This is an official change notification for the below parts. JAE has decided to make a **Change to gold plating area**

Part Number: **DX07WH24JA3**

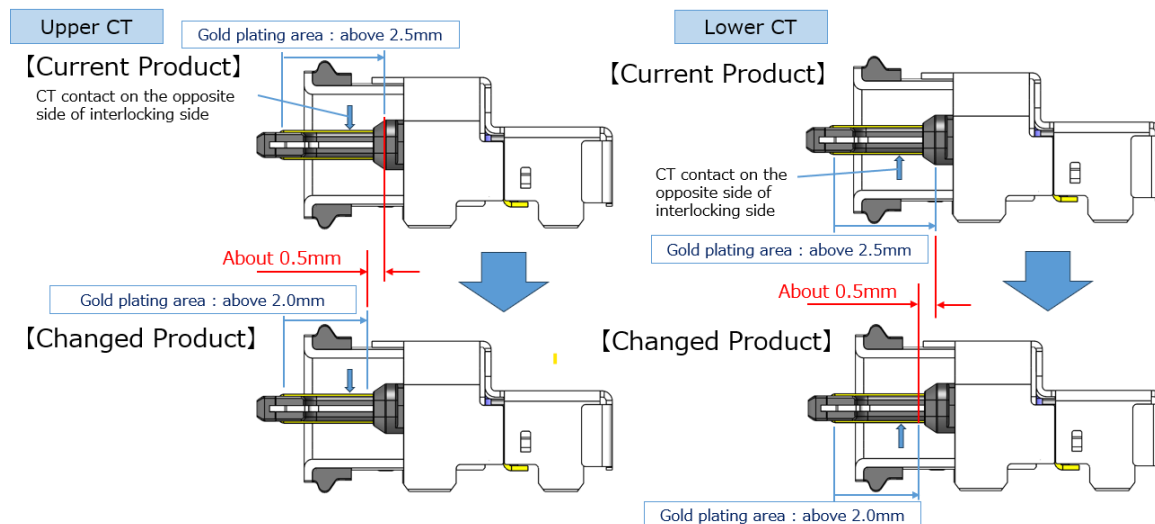
Please refer to the following picture, the area of gold plating will be changed within the range that does not affect the contact with the CT contact on the opposite side of interlocking side.
